Re: License Amendment Request for Fueled Experiments
License No. R-120
Docket No. 50-297

ATTACHMENT 1:
Safety Analysis in Support of Fueled Experiments for the NCSU
PULSTAR Reactor

SAFETY ANALYSIS IN SUPPORT OF FUELED EXPERIMENTS FOR THE NCSU PULSTAR REACTOR

LICENSE NO. R-120

Figure 3.8-1: Vented Fueled Experiment Fission Gas Release Rate

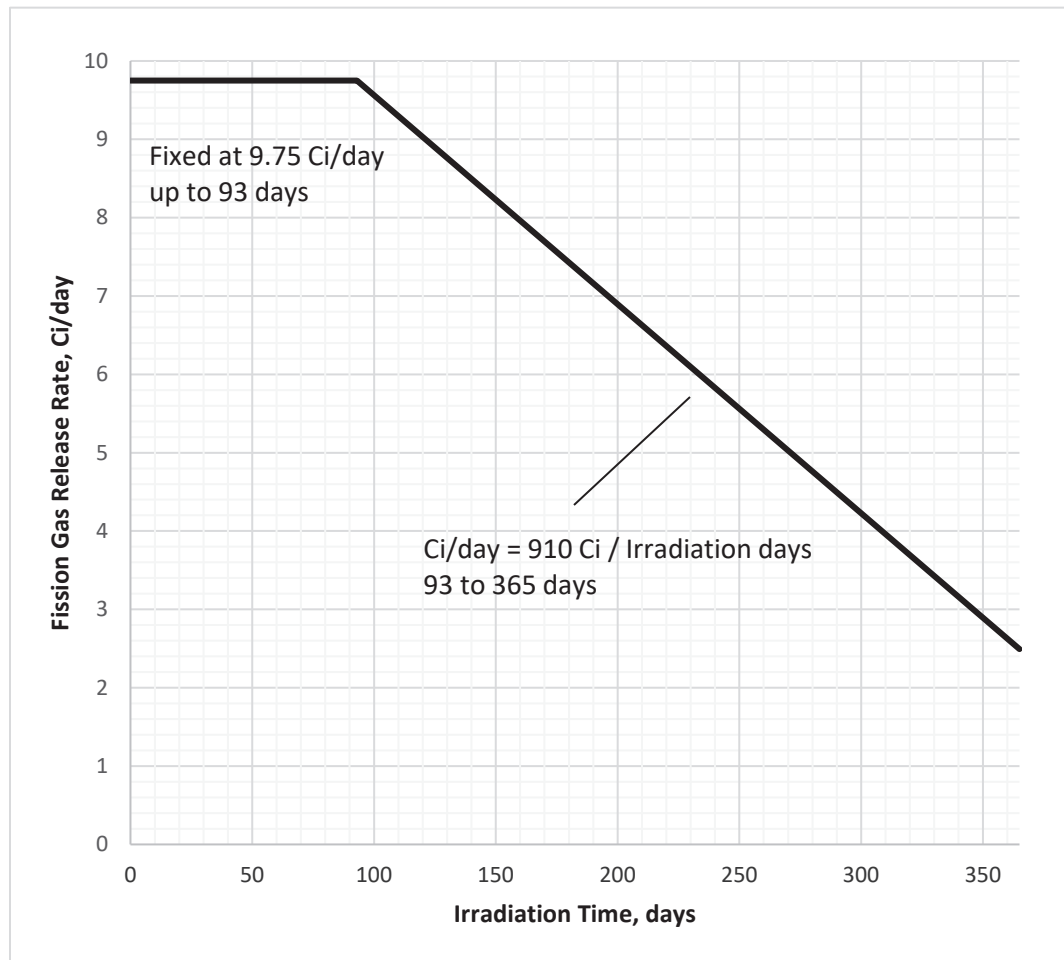
- i. 9.75 Ci per day from 1 to 93 days in a calendar year as depicted in Figure 3.8-1.
 - ii. 910 Ci divided by 93 days to 365 days in a calendar year as depicted in Figure 3.8-1.

Figure 3.8-1: Vented Fueled Experiment Fission Gas Release Rate

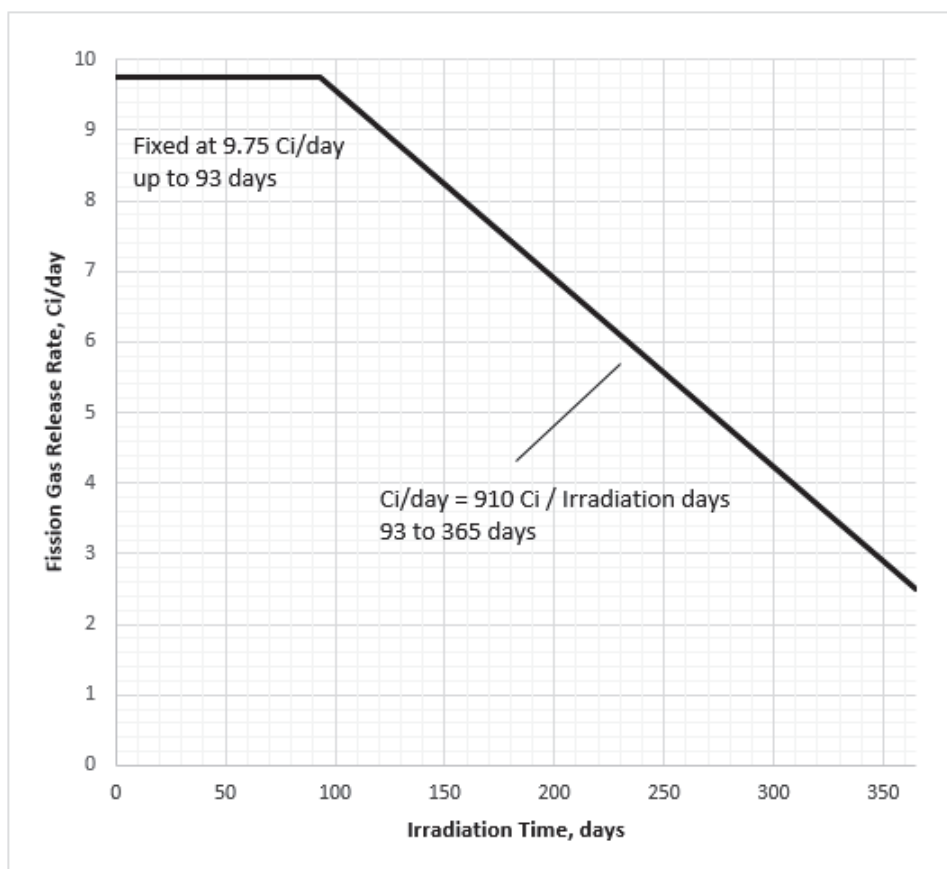
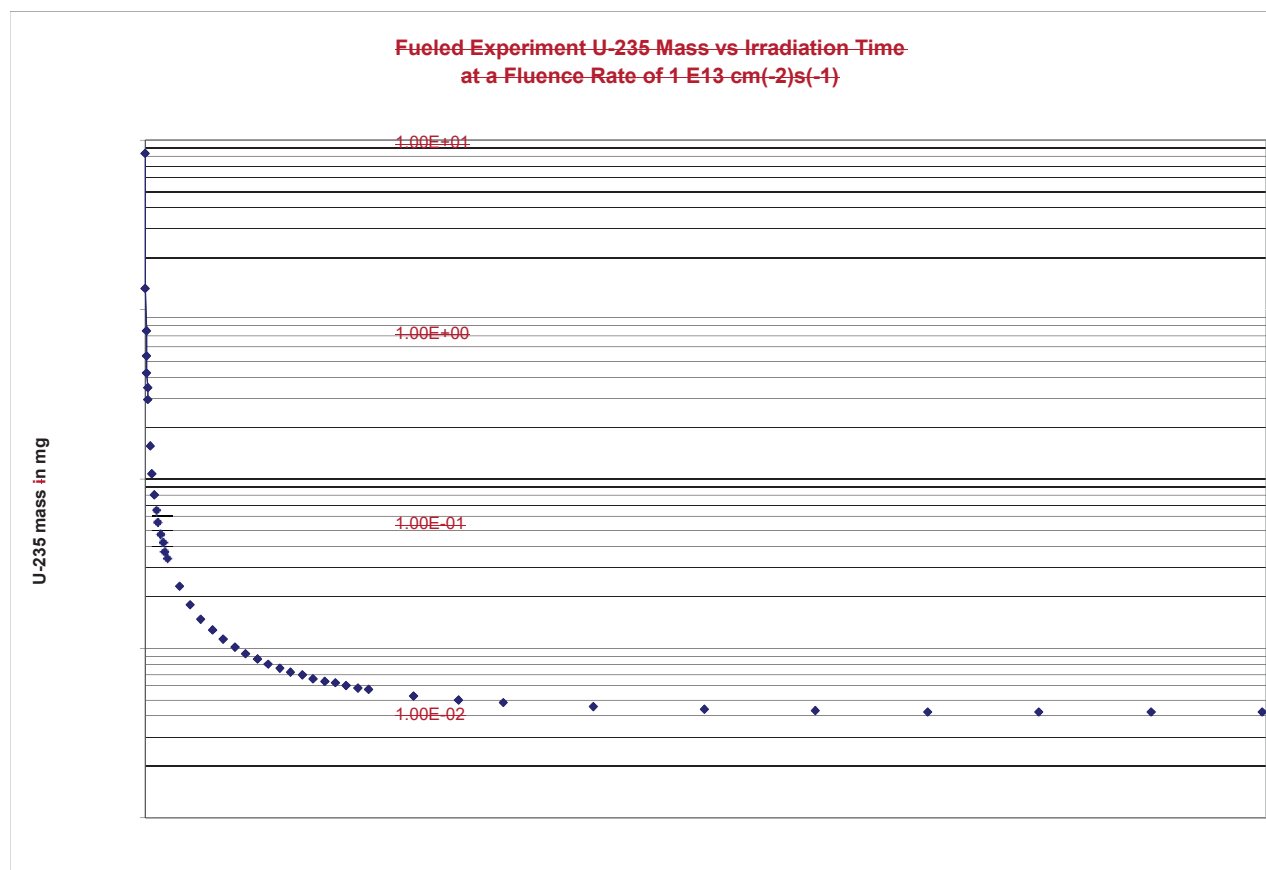
~~a. The mass, fission rate and power are limited as indicated in Figure 3.8-1 and Table 3.8-1.~~

- i. 9.75 Ci per day from 1 to 93 days in a calendar year as depicted in Figure 3.8-1.
 - ii. 910 Ci divided by 93 days to 365 days in a calendar year as depicted in Figure 3.8-1.

~~Credible failure of any fueled experiment shall not result in releases or exposures in excess of 10 percent of the annual limits established in 10 CFR Part 20.~~

NOTE: The mass at 500 hours may be used for periods up to 1 y (8760 hours).
